A/C TYPE EC155 B
 A/C S/N 6583
 A/C REGN 9M-8AS
 TYPE OF CHECK _____

DEFECT AND RECTIFICATION WORKSHEET/CERTIFICATE OF RELEASE TO SERVICE

ALERT SERVICE BULLETIN

**Modification of the wiring of the FLIGHT/GROUND logic
(connector 11 ALPHA)**

Figure 1

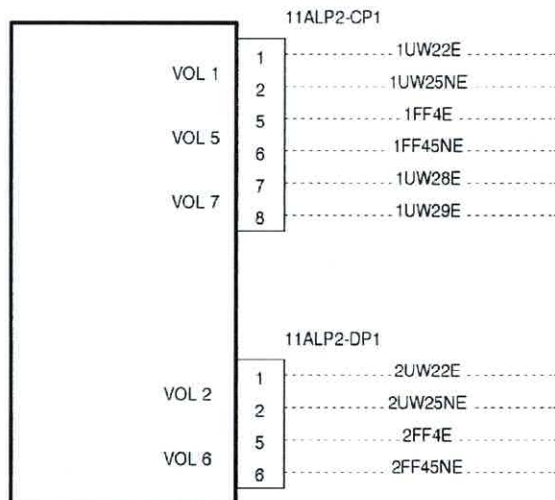
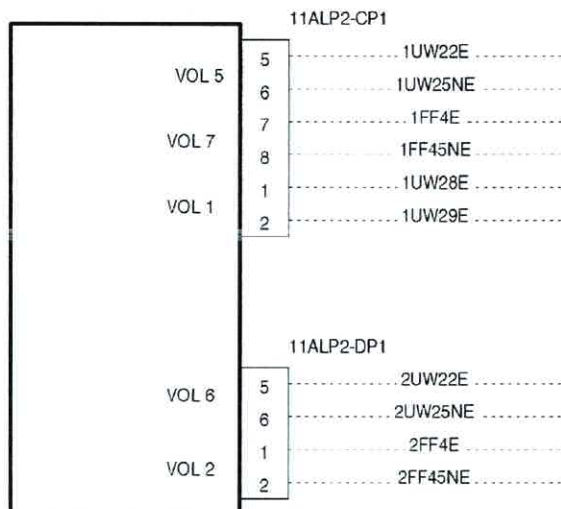
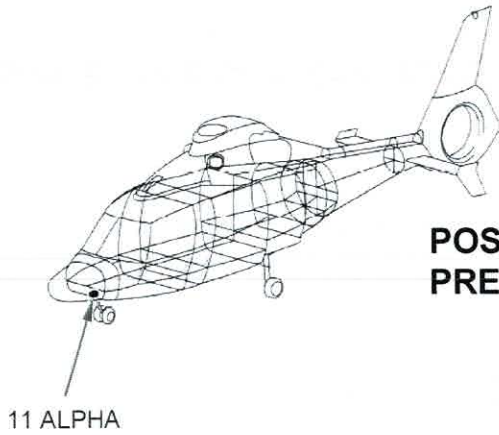
- 365A084754.00 which consists in re-allocating the electronic card outputs by modifying the connection to connector 11 ALPHA (helicopters PRE and POST MOD 0731B89),
- 365A084754.01 which consists in modifying the wiring of connector 11 ALPHA (helicopters POST MOD 0731B89).

- Perform the modification of the connection to connector 11 ALPHA as per [Figure 1](#).

Figure 2

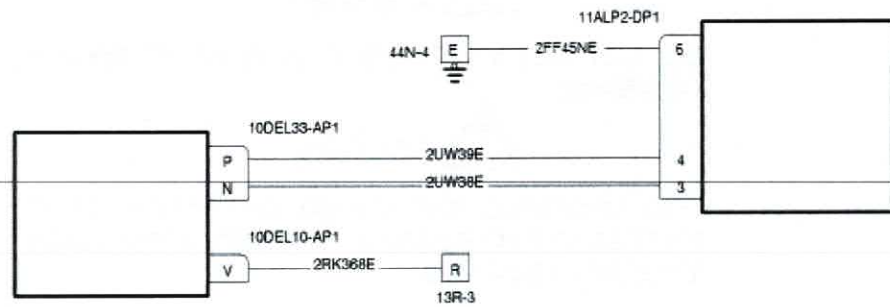
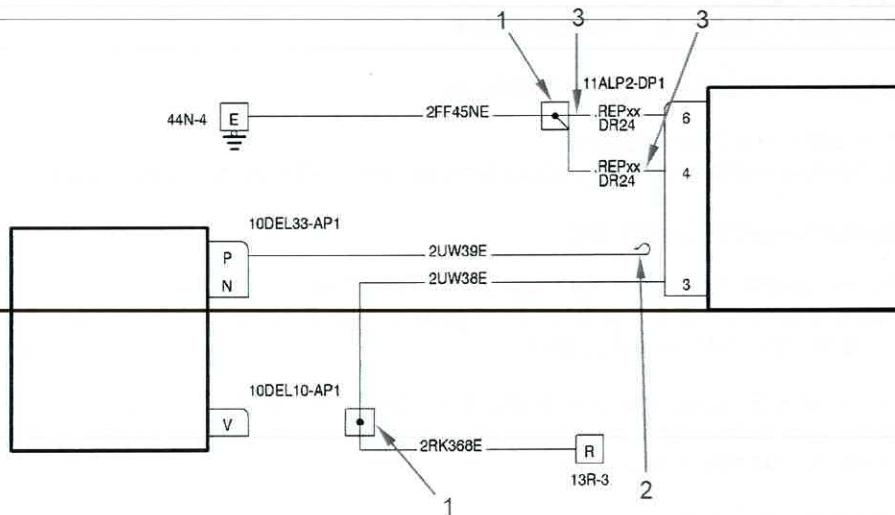
- Perform the modification of the connection to connector 11 ALPHA as per [Figure 1](#).
- Perform the modification of the wiring to connector 11 ALPHA as per [Figure 2](#).
